**RE: Responses to Data Requests
New England Clean Energy Connect Project
Natural Resources Protection Act and Site Location of Development Act permit
applications**

**Response to the
November 20, 2017, and December 12, 2017
MDEP Information Requests**

New England Clean Energy Connect (NECEC)

PHOTOSIMULATION 11: KENNEBEC GORGE Looking North, Moxie Gore, 3 Structure Option

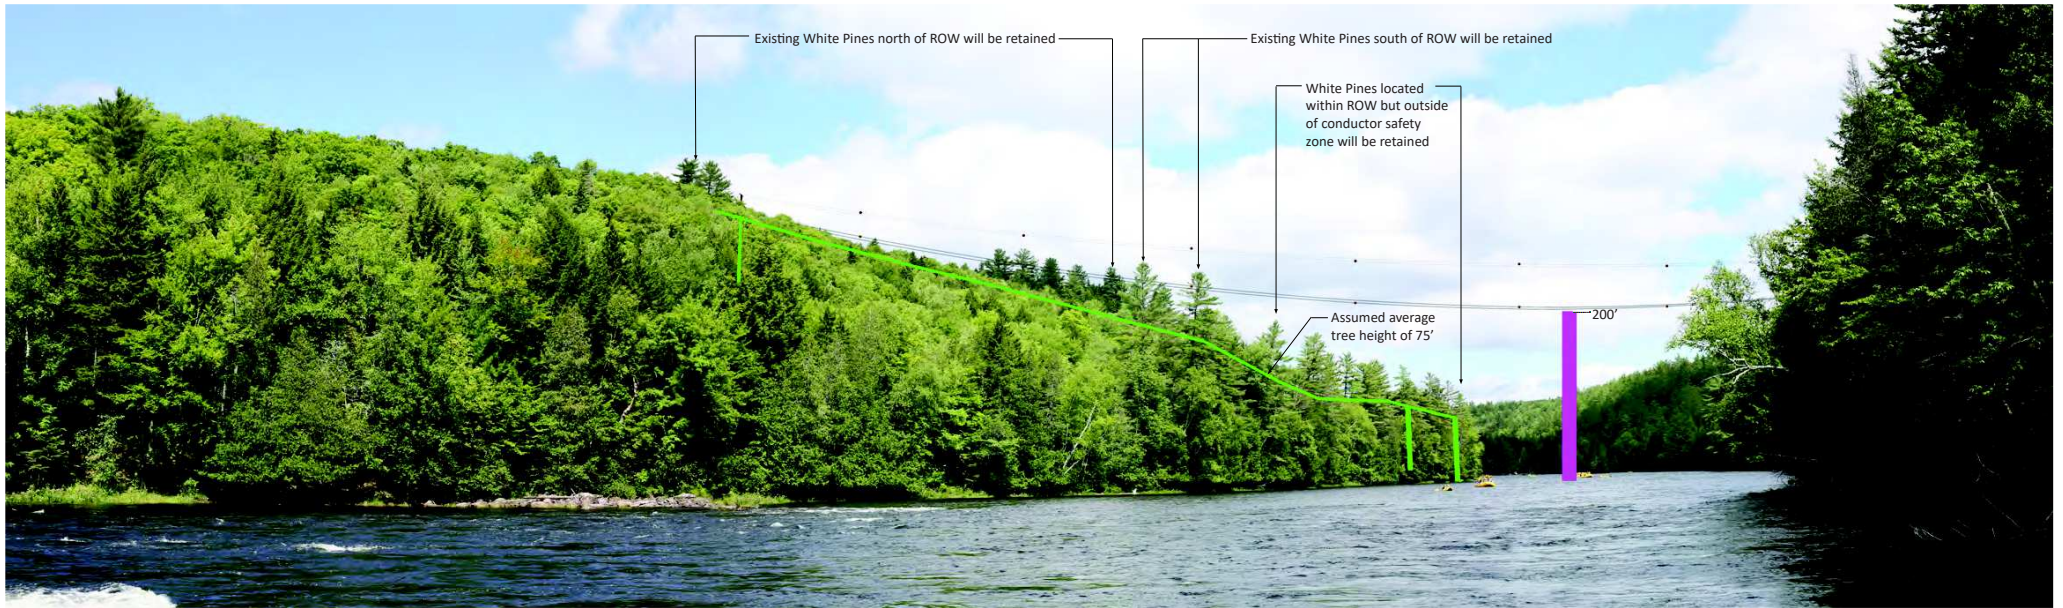
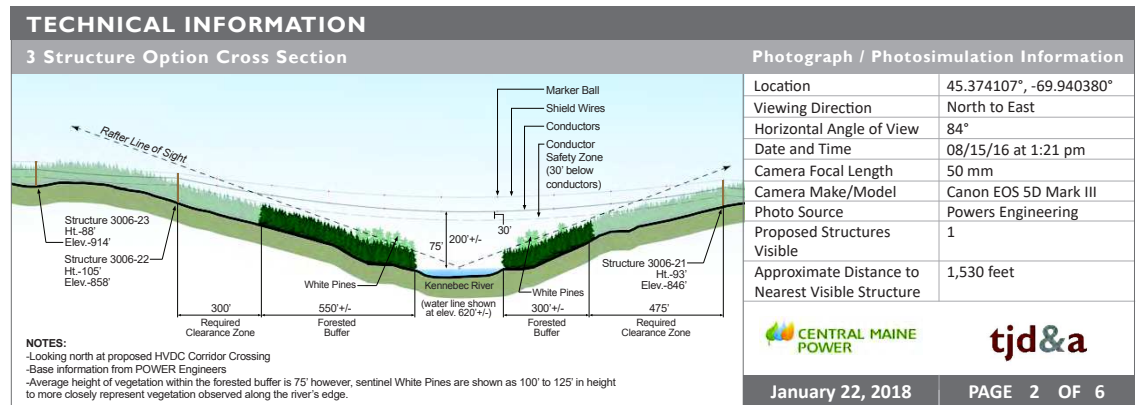
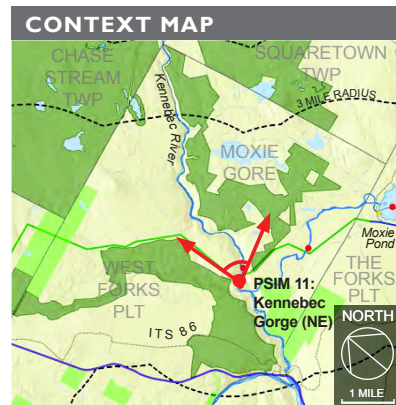
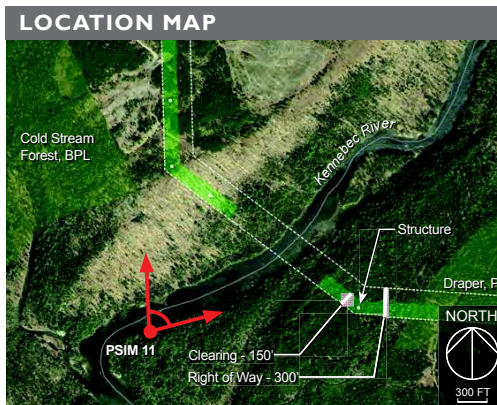
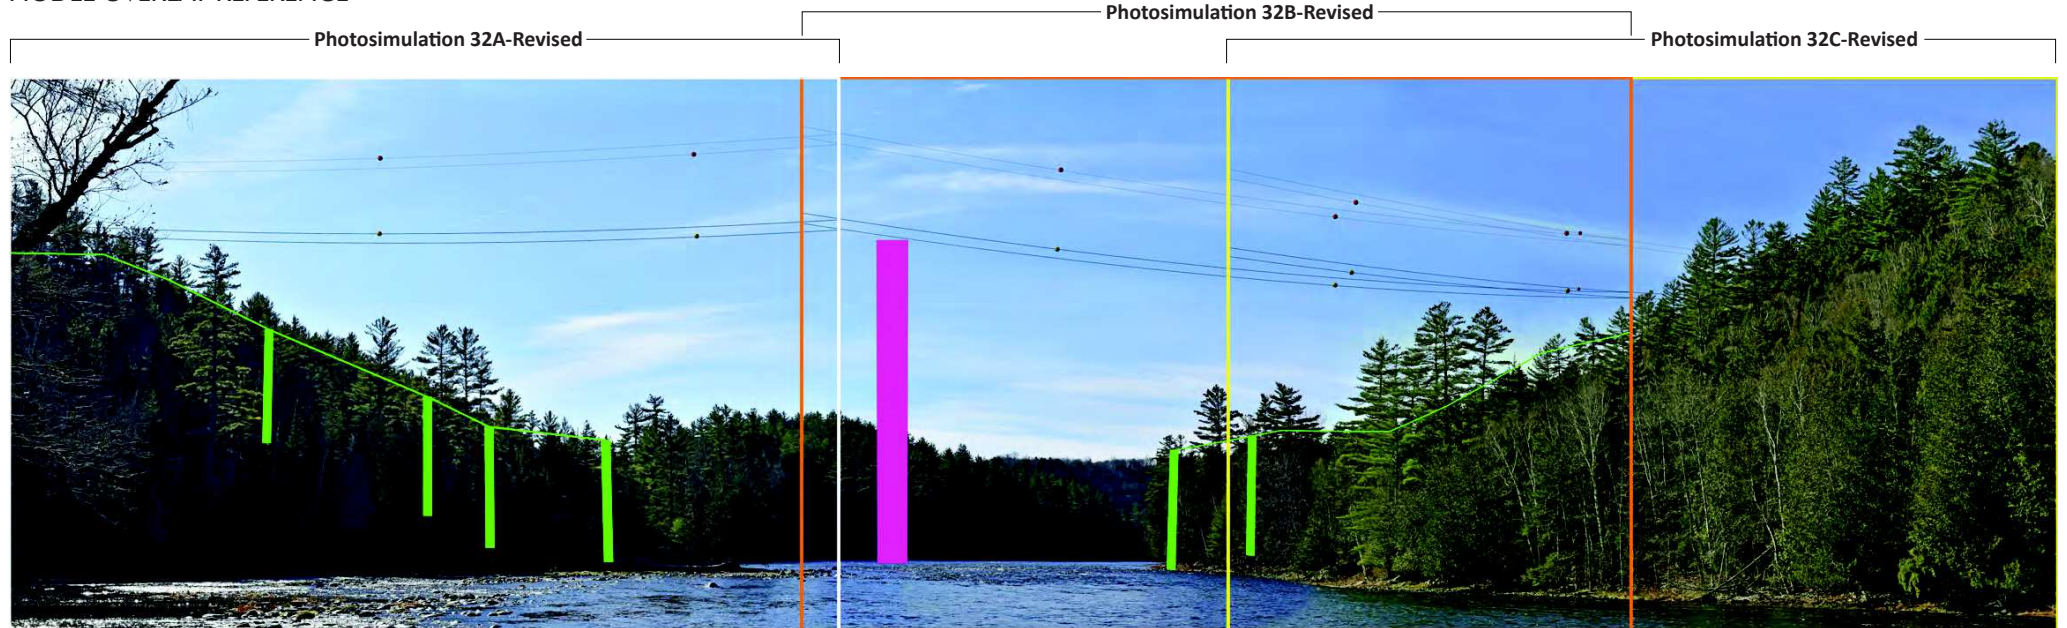
- 3. At the site visit on November 13, 2017 the applicant appeared to be working on a redesign of the crossing which would reduce the number of structures near the Kennebec River, elevate the conductors farther above the river, increase the undisturbed buffer along the river. Please provide the new design as soon as possible and include photosimulations which show the view looking directly into the corridor from the river. Also, quantify the vegetation that will need to be cut in the “buffer” area of the Gorge, both during construction and maintenance activities. The Department will need to have an understanding of the height of the conductors and the wire safety zone as well as the height of the capable vegetation that currently exists. If vegetation will be removed in this area (through maintenance activities) we need to evaluate that.**

CMP has since redesigned the Kennebec River Gorge crossing to increase and maximize the forested buffer on both sides of the river bank and to remove Structures 3006-21, 3006-22 and 3006-23 from the line of sight of users approaching the crossing point from upriver.

On the southeastern river bank approximately 300 feet of forested buffer will be maintained, with trees within this buffer at an average mature height of 75 feet. On the northwestern river bank approximately 550 feet of forested buffer will be maintained, with trees within this buffer also at an average mature height of 75 feet. At the centerline of the river, the conductor will be approximately 200 feet above the water level at maximum sag.

Advantages of the proposed 3-Structure design compared to the 5-Structure design include: fewer structures; greater vertical clearance over water; greater vertical clearance over trees; retention of trees over a larger area of forested buffer; and screened views of the transmission line structures and the cleared corridor from the perspective of river users.

CMP provided revised photosimulations and cross sections depicting the 3-pole structure redesign in an email to MDEP on December 12, 2017. Upon further conversations with LUPC, CMP is providing (attached to this submittal) revised photosimulations, dated January 22, 2018, of the 3-pole structure redesign, at a “normal view,” removing the distortion and providing a more accurate depiction of the conductor sag over the river. Additionally, the mark-up of the panoramic photos includes overlaid scale references and additional detail of the low point of the conductor sag and the assumed average of the 75-foot existing tree height. See Attachment A: Kennebec River Gorge Photosimulations.
